**Thursday, September 22, 2022  
7:00 P.M.**

**C. PSPR22-0015 – Site Plan review for Storage Rentals of America, 999 Silver Lake Road, zoned IND, Industrial District. Applicant is requesting to build a 24,000 square foot climate-controlled storage building.**

**E. PSPR22-0017 – Site Plan review for Fast Eddie's Car Wash, 1161 & 1209 N. Leroy Street, zoned GBD, General Business District.  
Applicant is requesting to remodel the existing car wash and façade**

- A. PSPR22-0008 – Site Plan Review for Texas Roadhouse, 18555 Silver Parkway, zoned GBD, General Business District/PUD, Planned Unit Development. Applicant is requesting to construct a new 8,039 square foot restaurant.**

**e. Loading Zone**

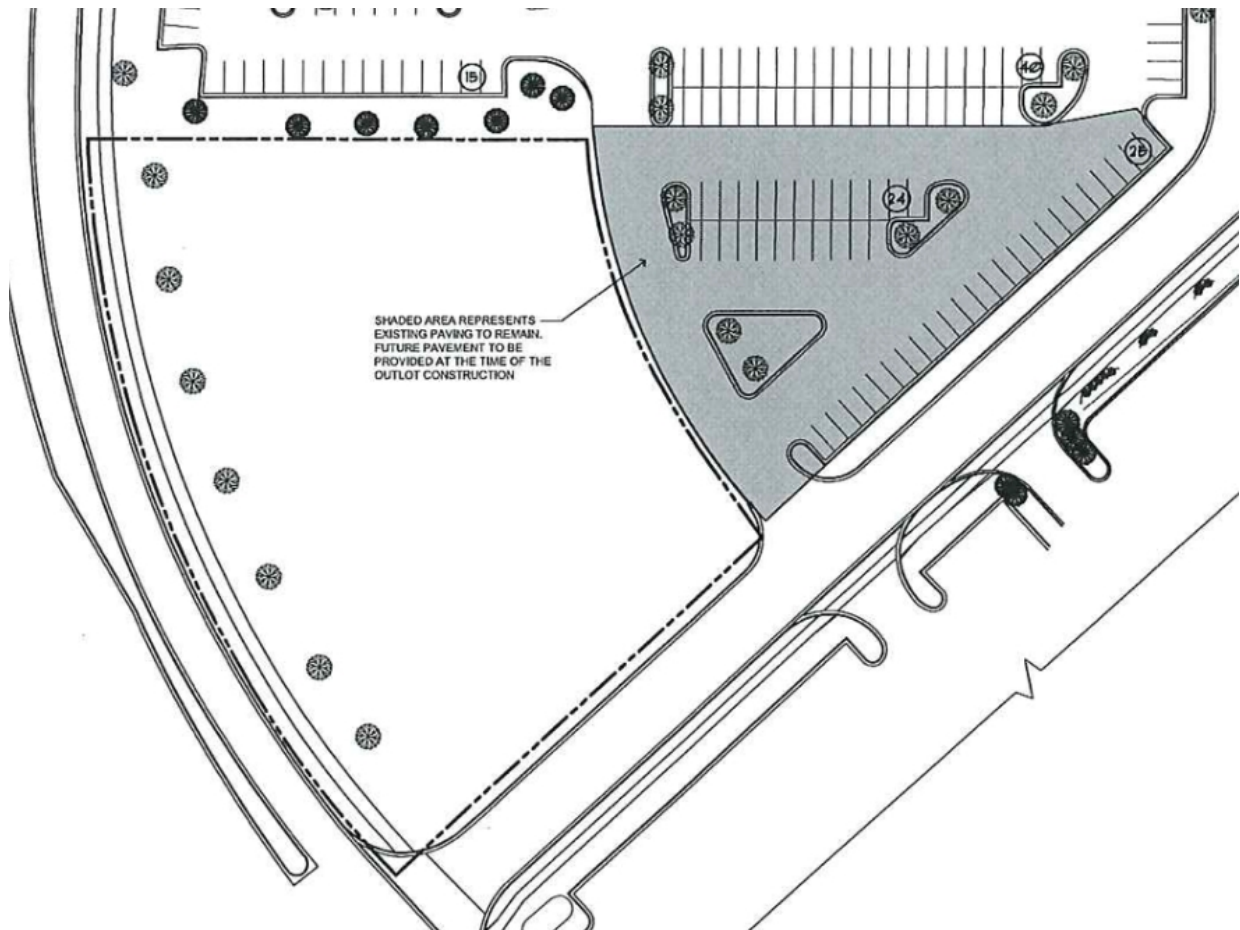
**Not in compliance:** a waiver is required for no loading zone being provided. There is likely not enough space for a loading zone and the application should indicate how this will be addressed.
